## Memorandum

Subject : **Staff Water Resources Rebuttal Testimony and Errata for Soil and Water Resources and Air Quality Testimony**

**REBUTTAL TESTIMONY OF LINDA D. BOND  
TO THE DIRECT TESTIMONY OF GARY A. LEDFORD  
ON WATER AND RELATED MATTERS (EXHIBIT 121) AND  
REBUTTAL TESTIMONY OF TO THE TESTIMONY OF  
JOSEPH O'HAGAN AND LINDA BOND  
ON SOIL AND WATER (EXHIBIT 99)  
FOR THE HIGH DESERT POWER PROJECT**

**Figure 1**  
**Worst Case Conditions for Project Operations**  
**Analyzed to Estimate Potential for Maximum Negative Impacts**

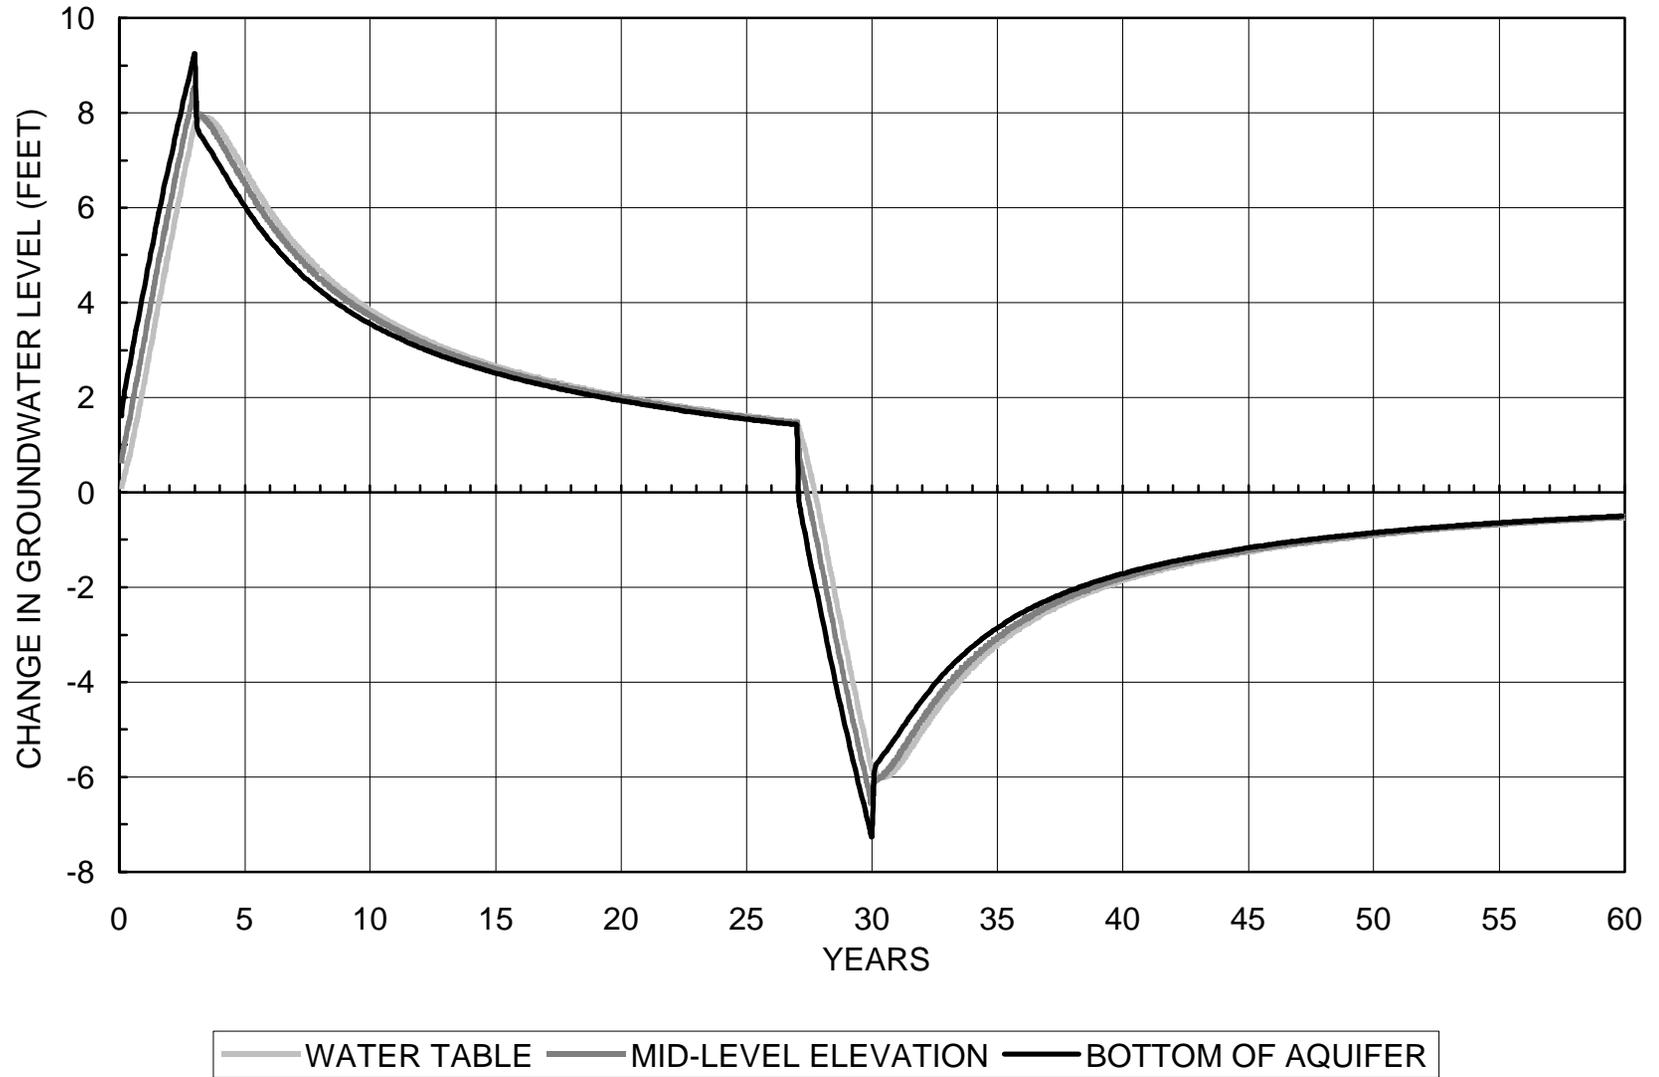
- 10 • **Project Operations** - The analysis would evaluate the worst case conditions for  
11 project operations. The worse case conditions would provide an estimate of the  
12 maximum negative impacts, given the maximum delay between initial injection  
13 and groundwater withdrawal that would occur for a 30-year project. In addition,  
14 the analysis would assume that project wells would be screened in the lower  
15 portion of the aquifer, which is also a conservative assumption (Figure 1).

**FIGURE 3. BASE CASE ANALYSIS OF CHANGE IN GROUNDWATER LEVELS  
IN THE MOJAVE RIVER ALLUVIAL AQUIFER WITH TIME**

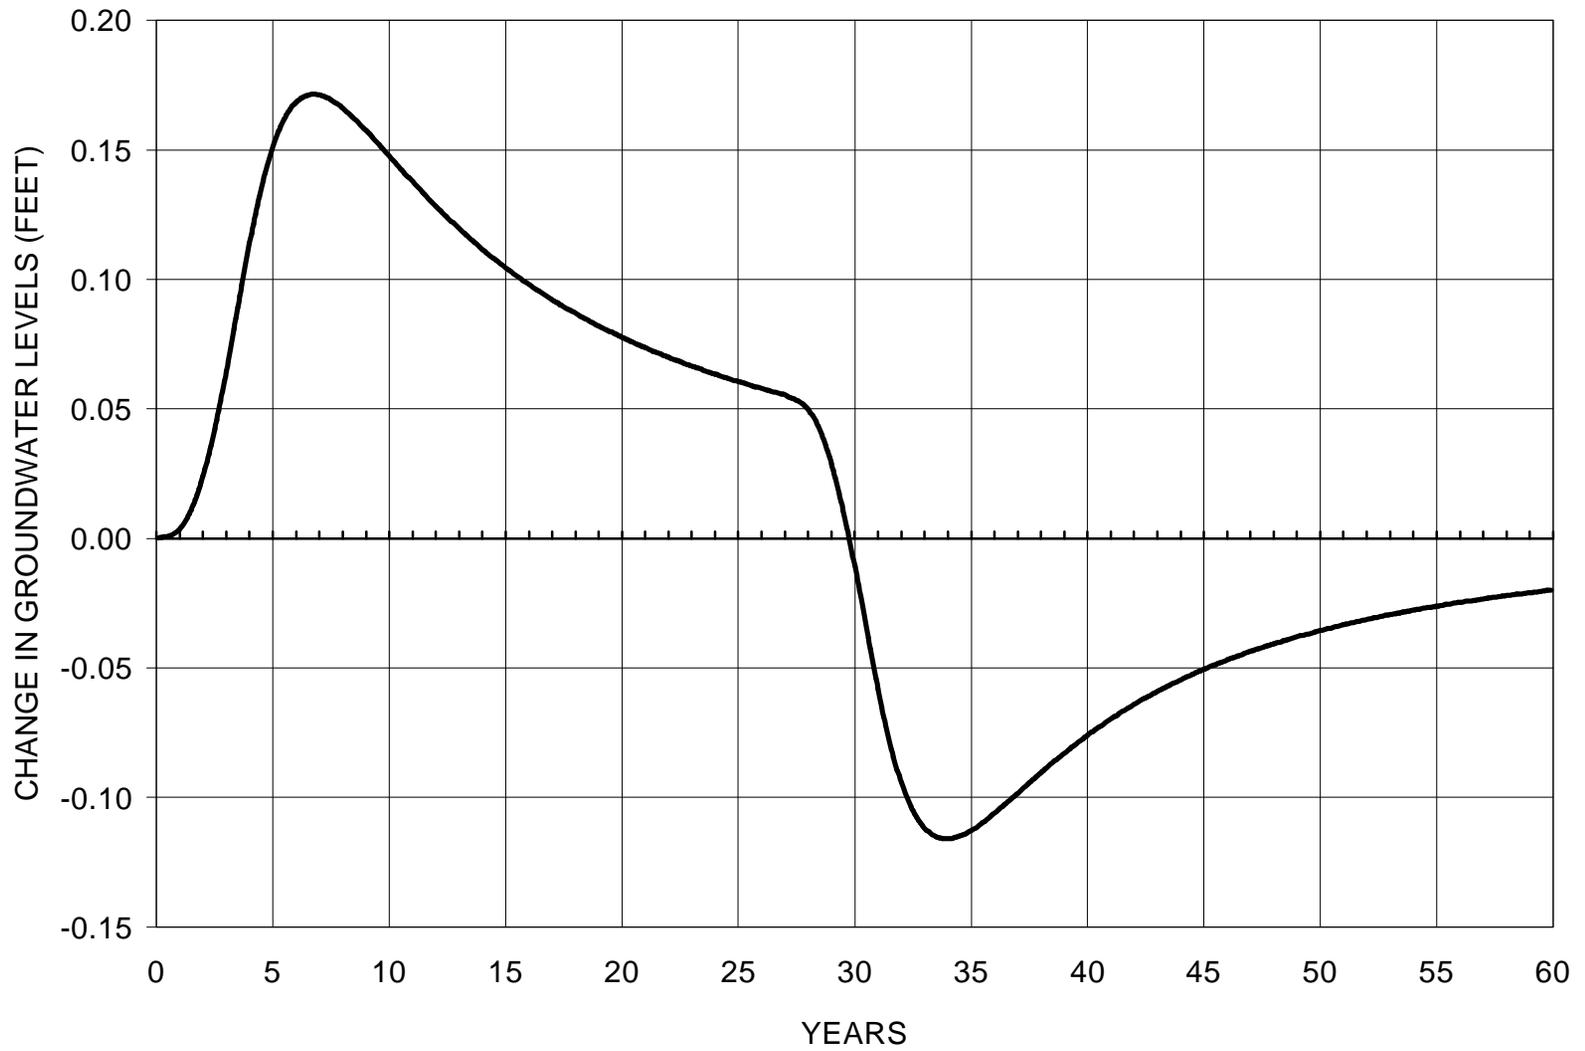
18  
19 Specifically, ~~under the~~ base case conditions, Staff analysis indicates that in this  
20 situation, a small negative impact to groundwater levels the Alluvial Aquifer,  
21 primarily in the Upper Reach, would occur (Figure 3). Groundwater levels in flow  
22 ~~from the Regional Aquifer to~~ the Alluvial Aquifer would increase ~~by 370 acre-feet~~  
23 over during the 30 years as a result of project injection. However, following project  
24 closure, a similar decrease in groundwater levels flow would be caused by  
25 groundwater withdrawal at the end of the project. This decrease would continue for  
26 more than 30 years. ~~The maximum rate of increase would be about 18 acre-~~  
27 feet/year, and the maximum rate of decrease would be about 14 acre-feet/year.

**FIGURE 4. BASE CASE ANALYSIS  
IMPACT TO BASE FLOW OF THE MOJAVE RIVER SYSTEM**

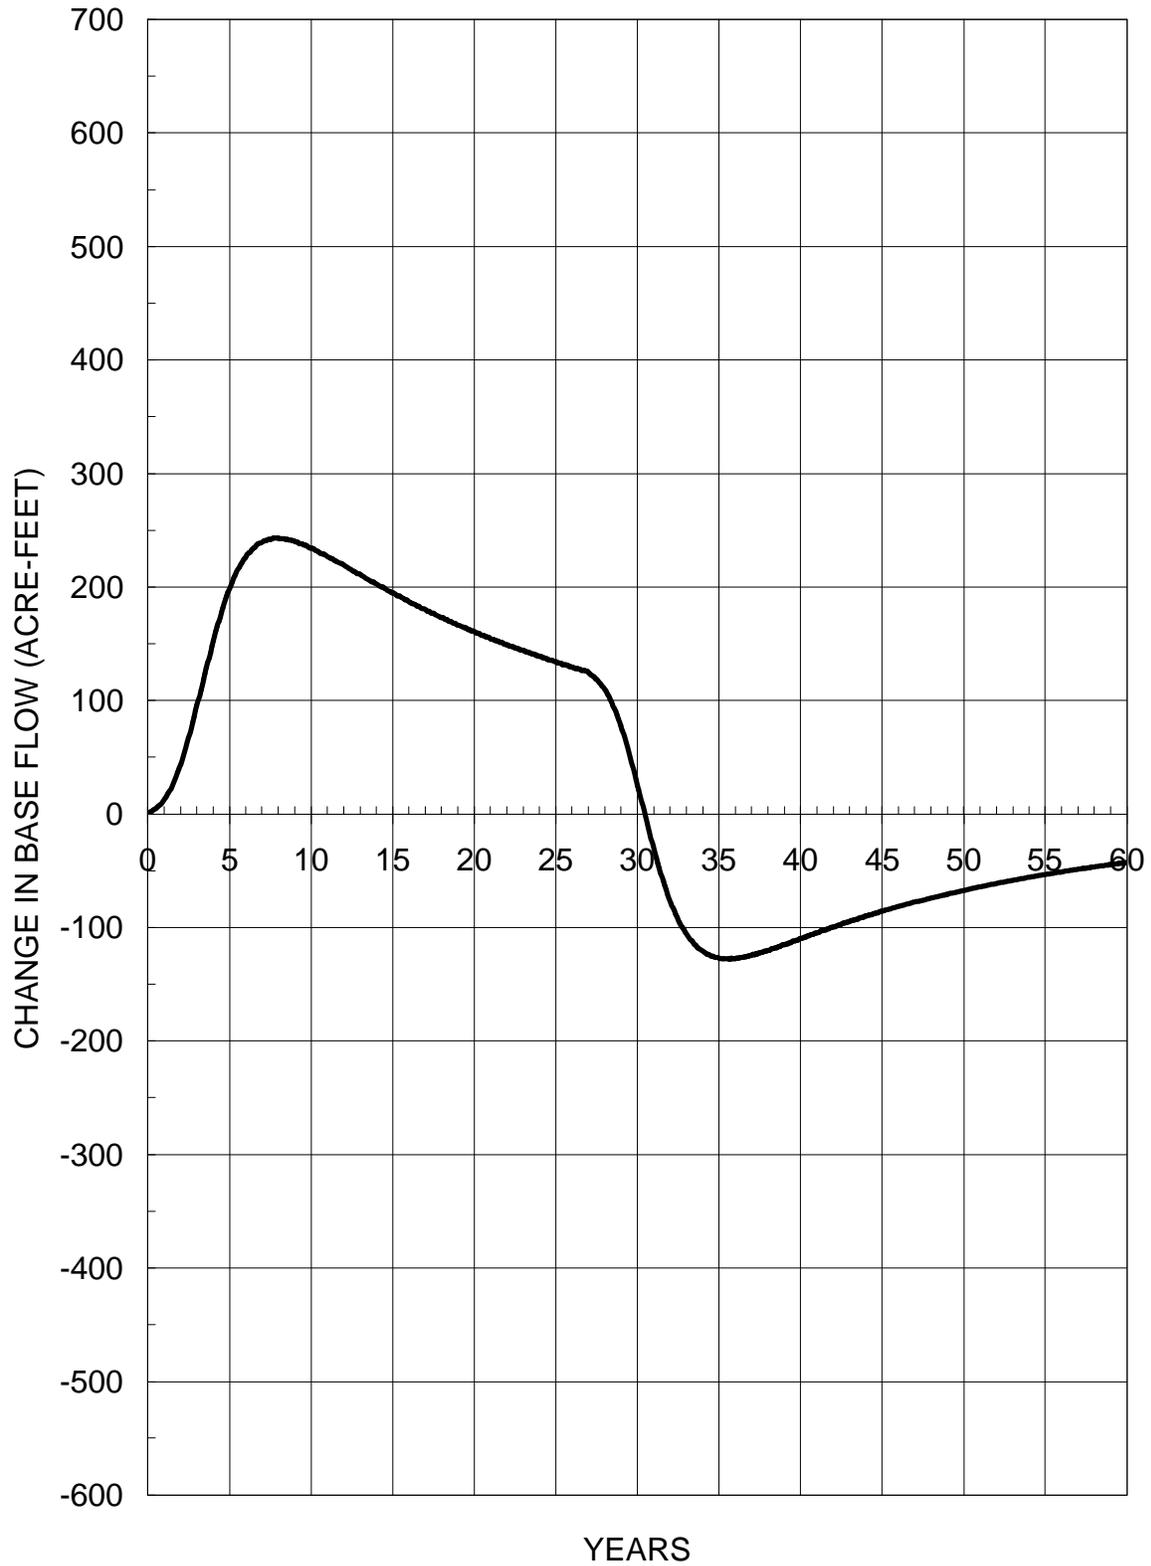
28  
29 In addition, there would be much greater impacts to the overall base flow to the  
30 Mojave River system. Base flows to the live stream plus groundwater discharge to  
31 the Alluvial Aquifer would increase to ~~over 200 a maximum rate of 240~~ acre-  
32 feet/year, and the maximum rate of decreased flow would about 130 acre-feet/year  
33 as shown in Figure 4. A total increase of 4,400 acre-feet of groundwater would  
34 discharge to the Mojave River Alluvial Aquifer in response to the project injection in  
35 the base case analysis. However, subsequent groundwater pumping for the project  
36 would not recover this water. As a result, following project closure, a total decrease  
37 in groundwater discharge of 2,100 acre-foot would occur over the next 30 years.  
38 ~~Neither base flow nor groundwater levels would fully recover during this period.~~

**FIGURE 10. SENSITIVITY TEST: REGIONAL AQUIFER  
SPECIFIC YIELD (Sy) = 6 PERCENT -  
IMPACT TO BASE FLOW OF THE MOJAVE RIVER SYSTEM**

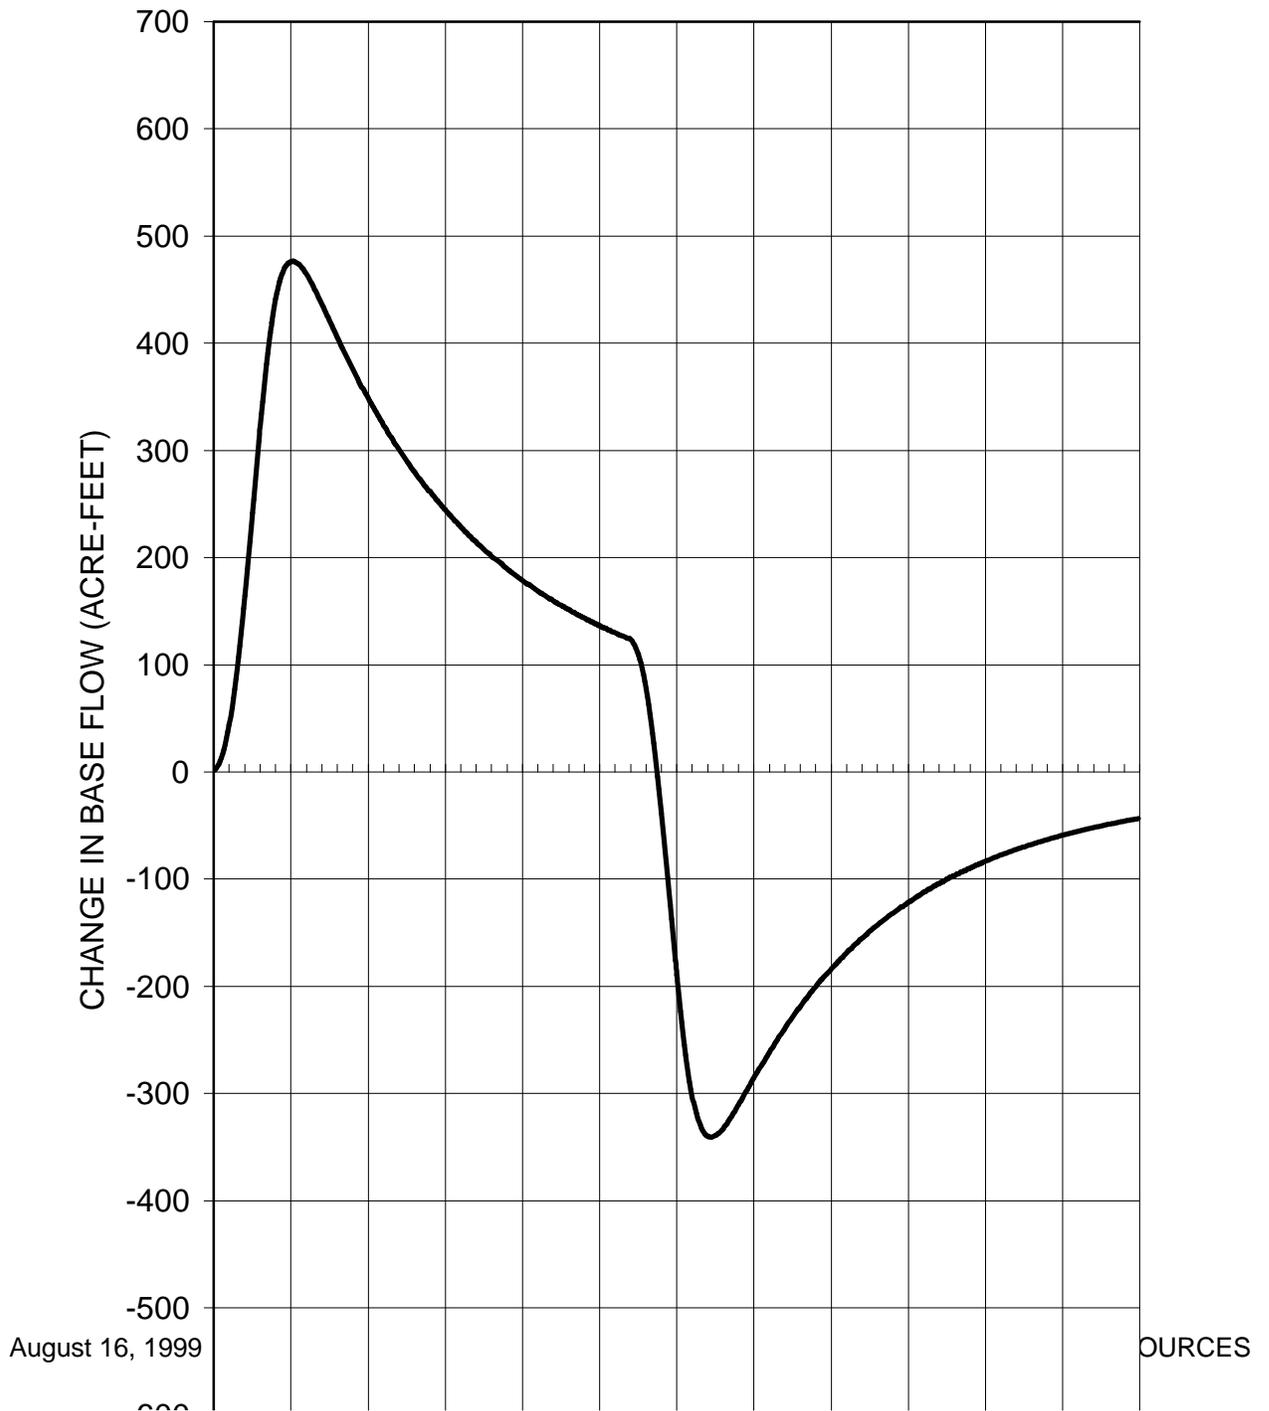
34 impact calculated for the base case (Table 6). The test for the second sensitive  
35 parameter, specific yield, considered a value of six percent compared to twelve  
36 percent used in the base case. This test indicated that a specific yield in the range  
37 of six percent would indicate more than double the estimated impacts to base flows  
38 of the Mojave River (Figure 10).  
39
